SERVICE INFORMATION LETTER

SERVICE INFORMATION LETTER INDEX

FIGURE 1

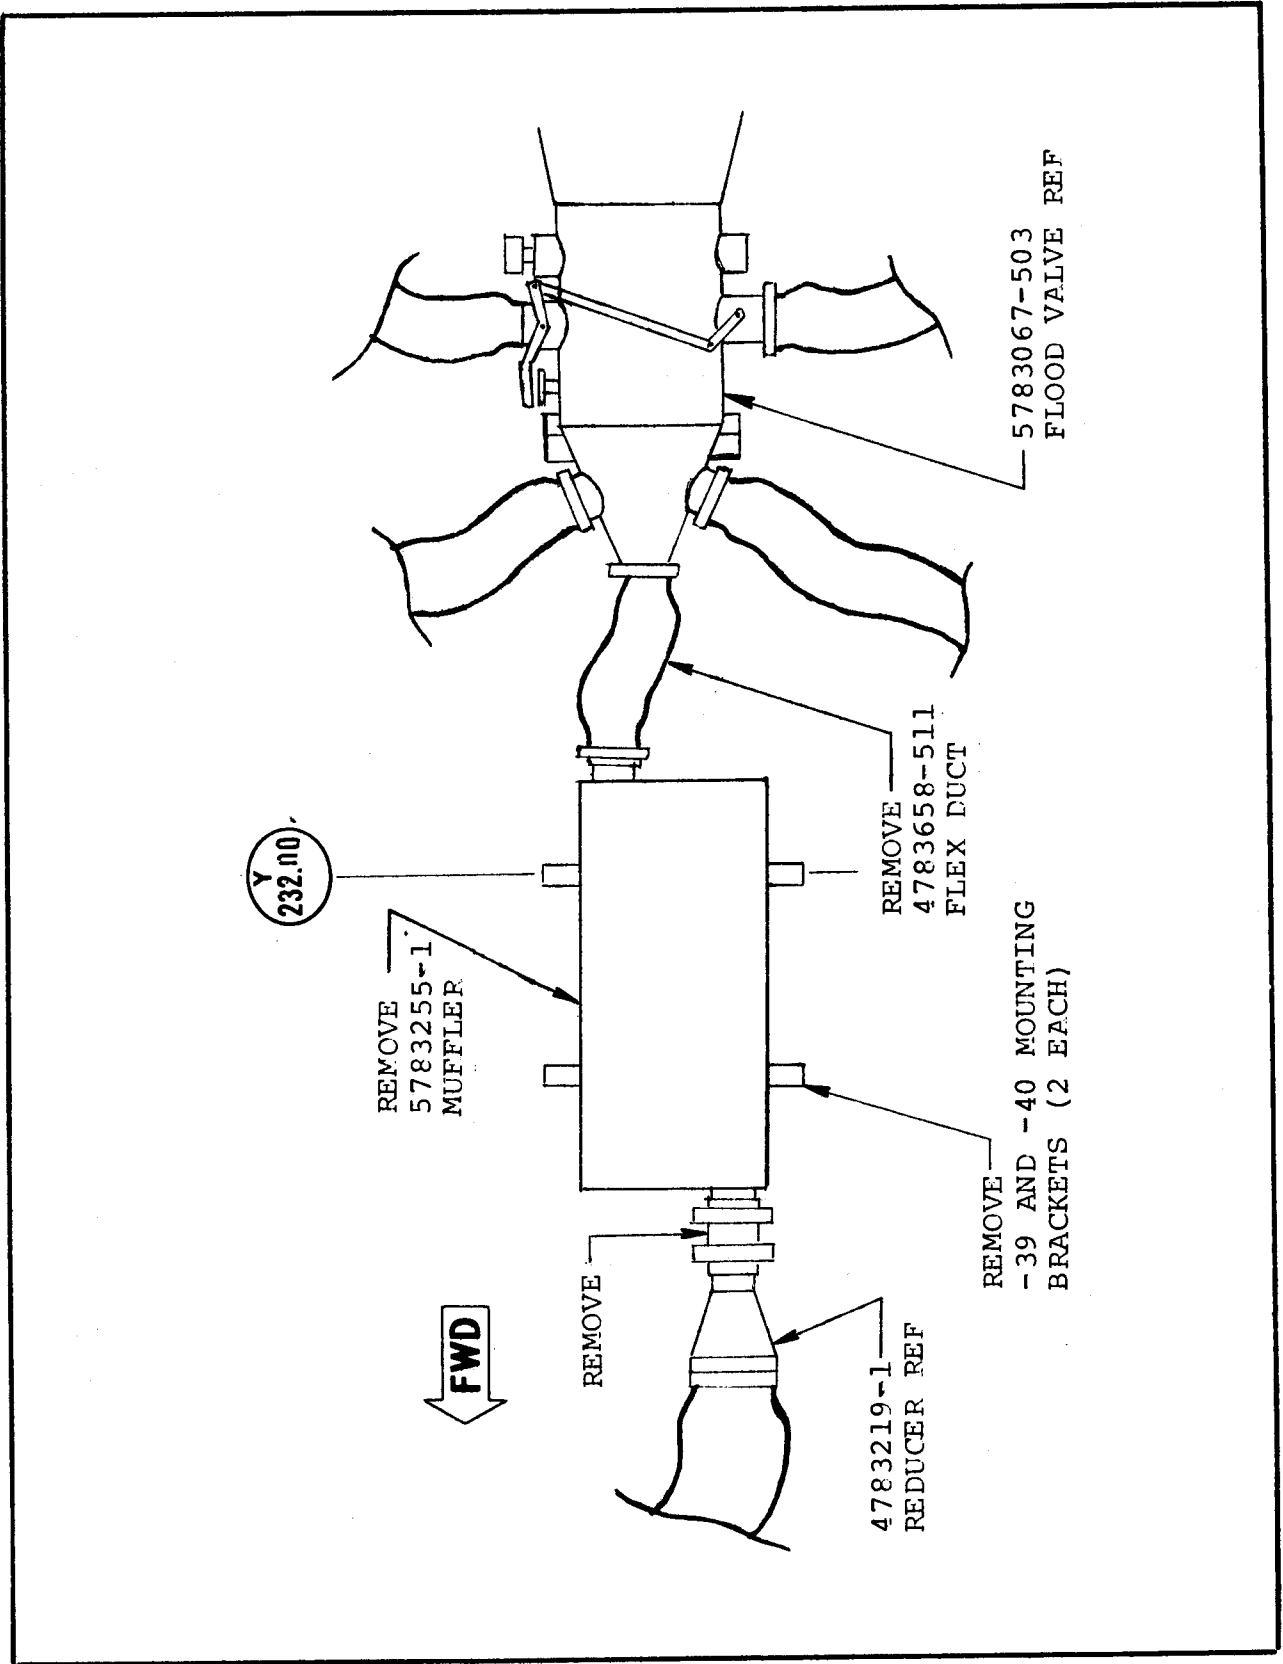
1. Gain access to air-condition muffler under the floor in rear cabin area.
2. Remove floor as required to enable work.
3. Disconnect and remove Muffler P/N 5783255-1, Flex Duct P/N 4783658-511, coupling duct, and Clamps P/N U84-210SH. Drill out rivets of -39 and -40 muffler mounting brackets; remove brackets. (SEE FIGURE 1)
4. Install Flex Duct P/N 4783658-523 between Reducer P/N 4783219-1 and Flood Valve P/N 5783067-503, using 2 each Clamps P/N U84-210SH originally removed (SEE FIGURE 2).
5. Relocate one -40 bracket to provide support for Flex Duct P/N 4783658-523, and secure with NAS1398D4-2 rivets. Install Clamp P/N MS21919DG35; locate and drill .190 dia. hole in -40 bracket for proper alignment of Flex Duct. Secure Clamp to bracket with AN3C4 Bolt, AN960-10L Washers (2 required), and MS20365-1032 Nut. (SEE FIGURE 2)
6. Close up floor and reinstall interior.

FIGURE 2

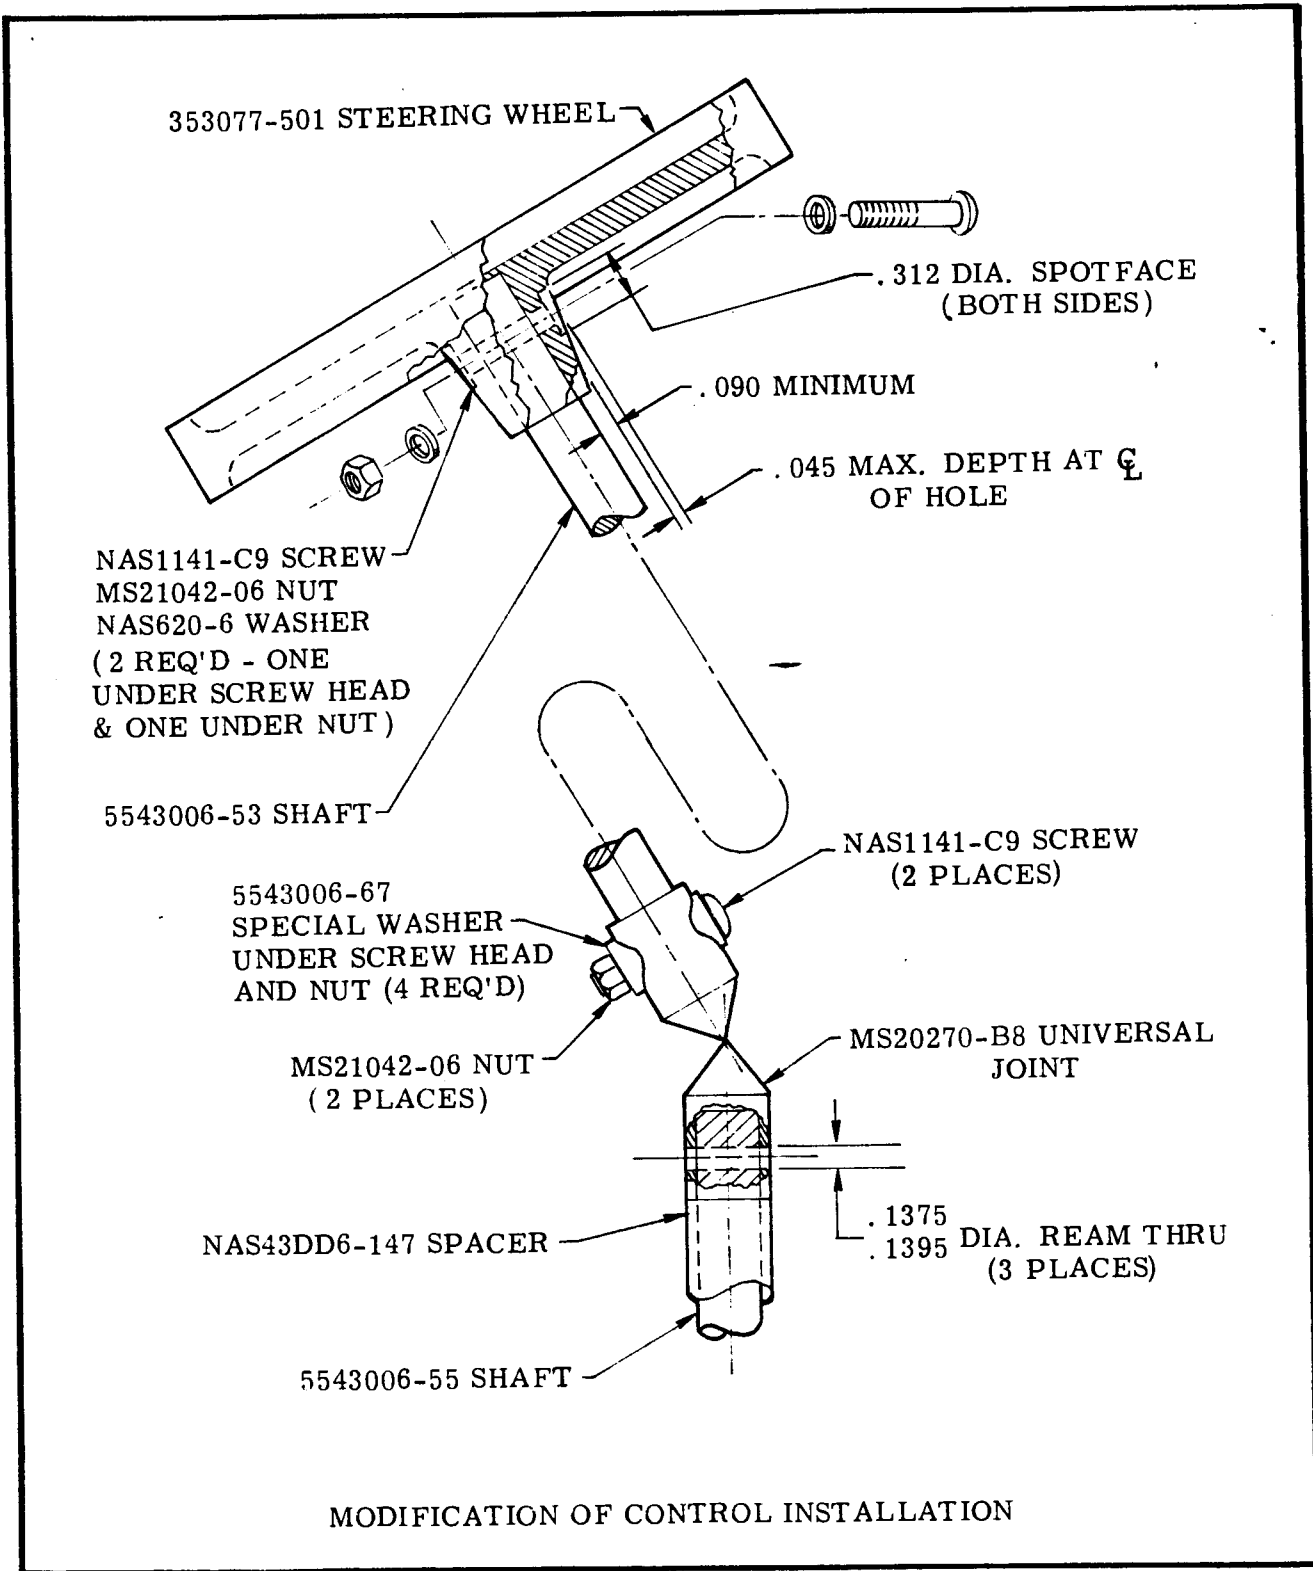
2. Remove 3530077-501 steering wheel from 5543006-53 shaft by driving out the MS16562-224 roll pin.
3. Drive out MS 16562-222 roll pins (2) connecting MS20270-B8 universal joint to 5543006-53 and 5543006-55 shafts. Ream through universal joint and shafts with .1375 dia. reamer. (SEE FIGURES 1 & 2)

4. Install NAS 1141-C9 screw, two 5543006-67 special washers, and MS21042-06 nut, NAS 620-6 washers at both locations on universal joint. (SEE FIGURE 2)

5. Enlarge existing fastener holes in 3530077-501 steering wheel with .1375 dia. reamer. Spot face hub as shown (maintain .090 minimum thickness). (SEE FIGURE 2)

FIGURE 2

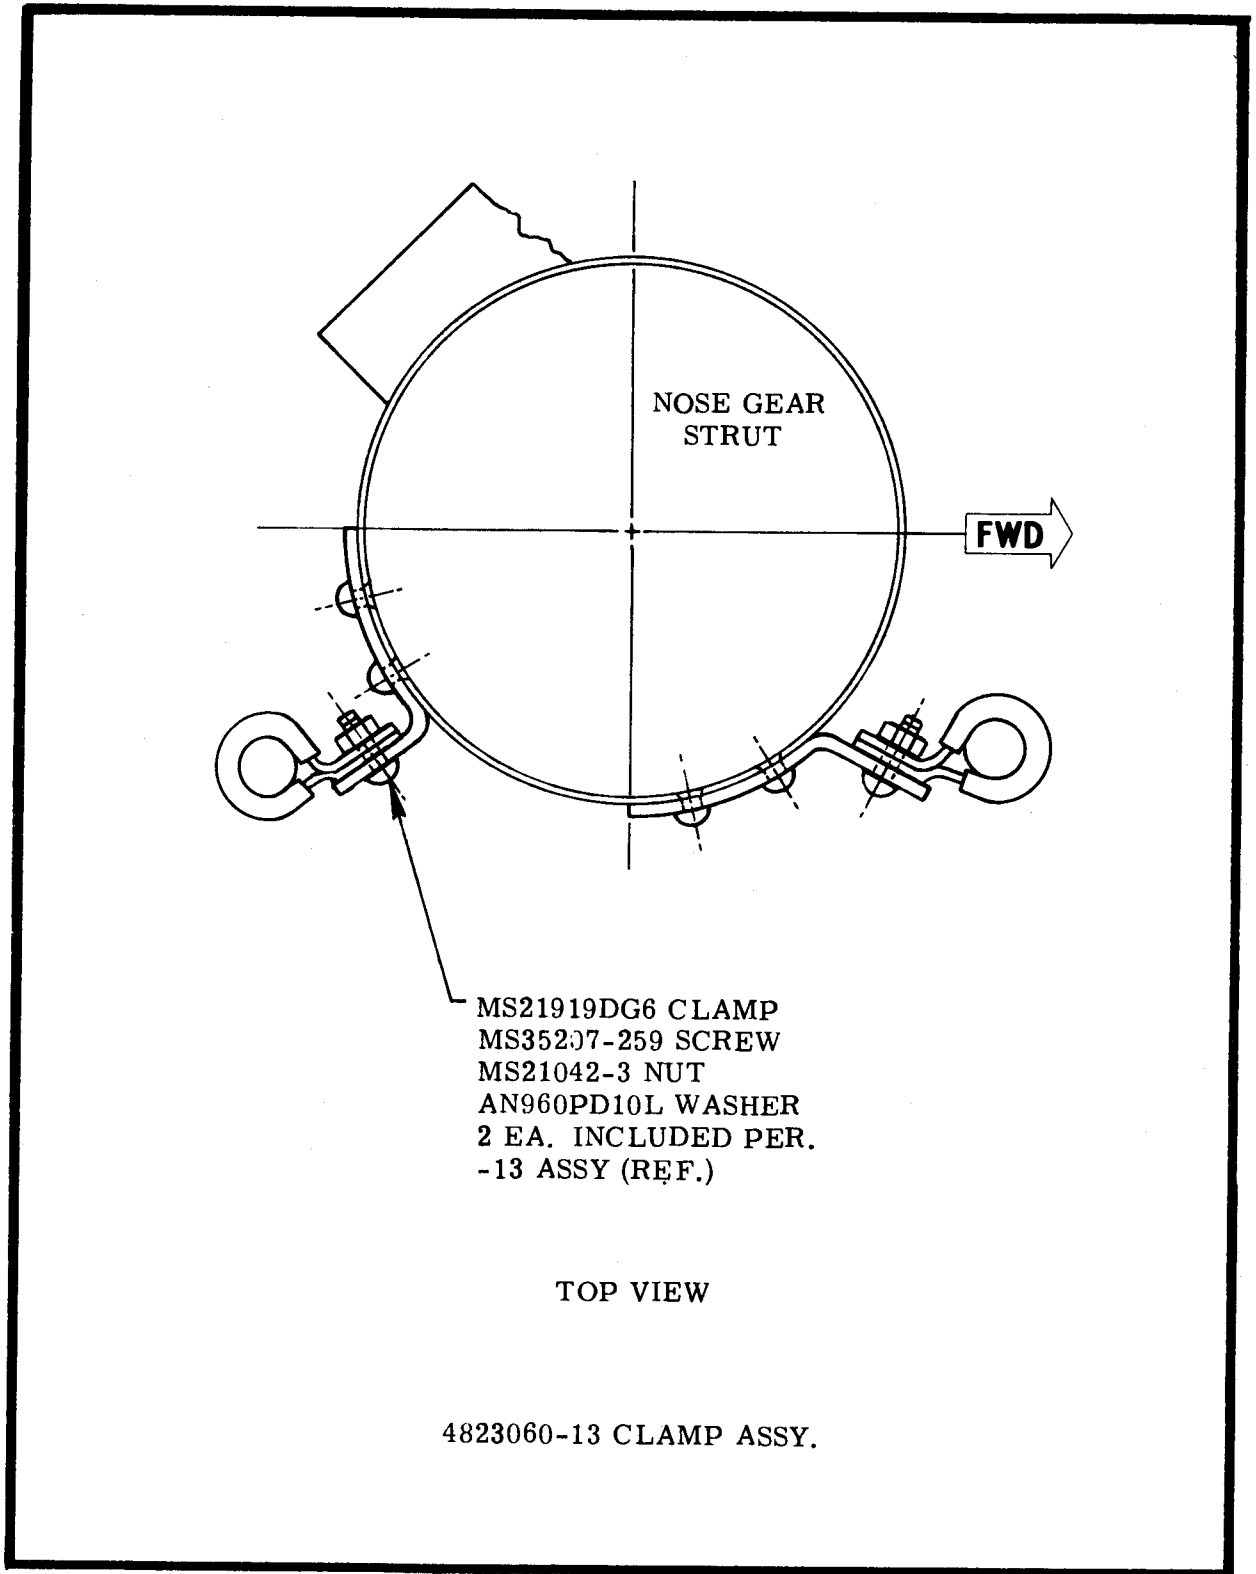
3. Install new MS25281-R8 wire bundle support clamp to 4823060-3 plate, using hardware provided, per Figure 1. Install new P/N 4823060-13 clamp assembly on nose gear strut body as per Figure 2. Check wire bundle for proper routing and freedom from stress between support clamps when nose gear is rotated to full deflection in left and right turns.

FIGURE 1

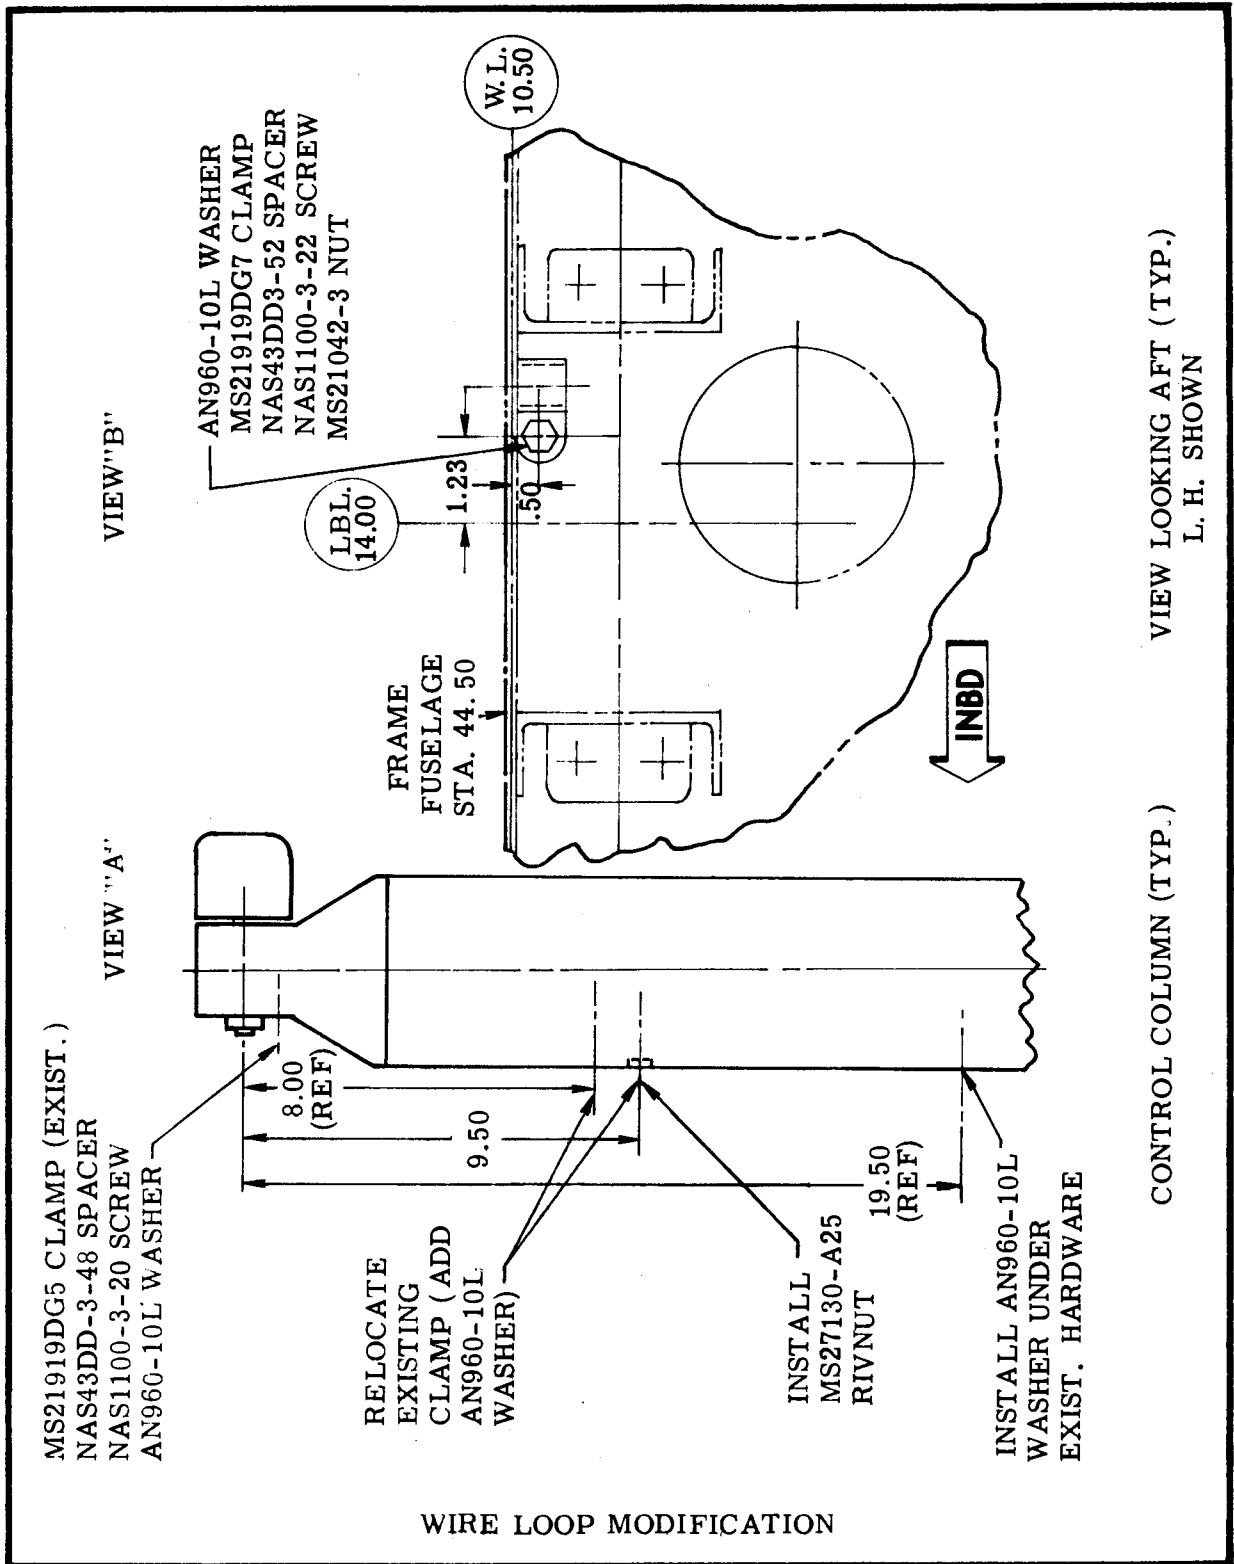
Procedures apply to both control columns. Refer to View "A", Figure 1 and proceed as follows:

5. Using View "B", Figure 1 as a guide, perform the following operations both L. H. and R. H. sides: locate and drill a No. 10 hole in fuselage frame at Station 44.50 at 15.23 inches outboard of fuselage centerline, and .50 inch below

FIGURE 2

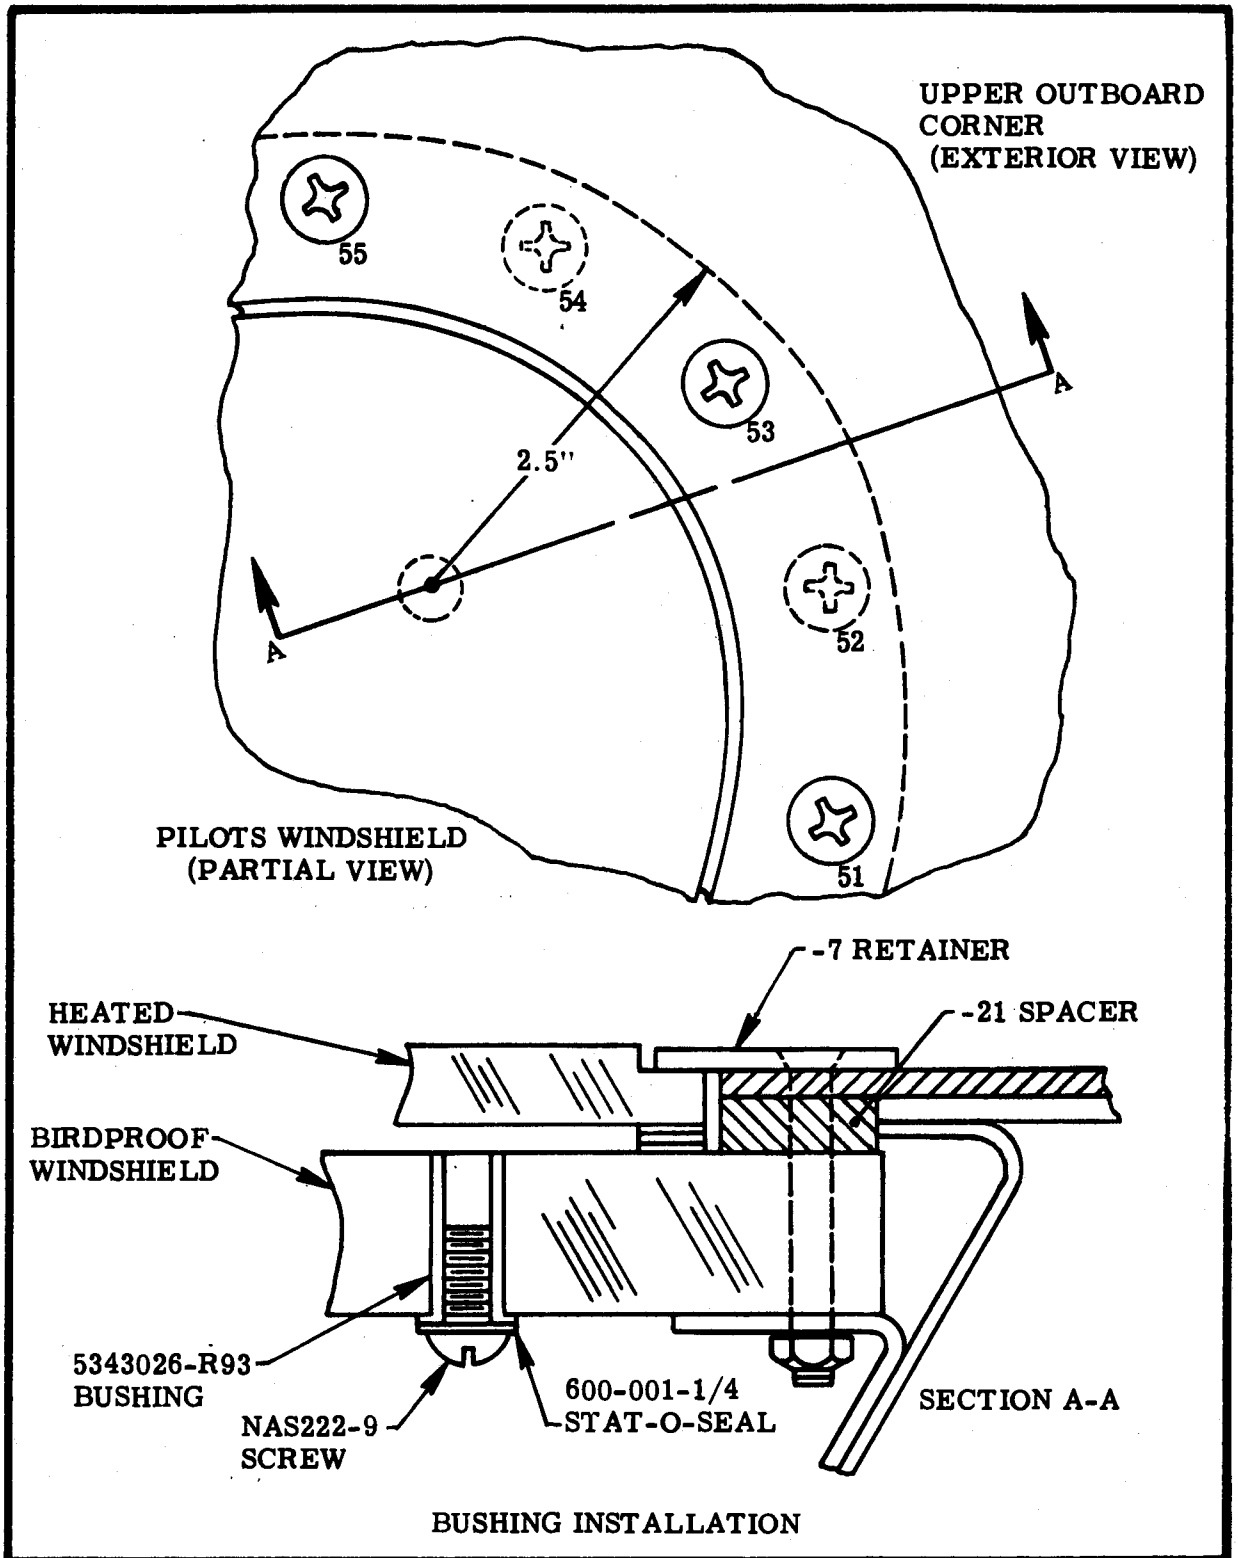
1. Remove outer windshield in accordance with Chapter 56-10-01, 1124 Westwind Maintenance Manual.
2. Apply masking tape to inner surface of each windshield, in upper outboard corner, sufficient to cover area depicted by Figure 2. (Left side shown; Right side opposite).
3. Locate and drill a 0.377 diameter ("V" size drill) hole in Birdproof Windshield per Figure 1. Ream hole as necessary to facilitate installation of 5343026-R93 bushing. Remove masking tape and break sharp edges.
